June 15, 2016

Re: Plan Commission Meeting Comments (June 8, 2016) – Park District Responses for Sunset Meadows Park Protective Netting Project

at 5' above ground.

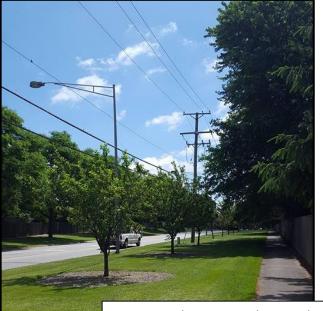
3. Re-evaluate the need for the 2 pedestrian gates along Kirchoff. If they are necessary, please explore the option for lockable gates or a more secure means to prevent young children from slipping out and chasing balls across Kirchoff.

The Park District would like to propose a modification to the opening previously discussed. In lieu of simple 4-foot wide openings in the aluminum fence, the Park District will install 4-foot wide gates at these two (2) locations. The gates will be hinged and latchable. The latch will be mounted at a height (5' above ground) limiting access for small children,

only allowing adults to unlatch. The Park District will also work with the netting installer for an alternative to Velcro.
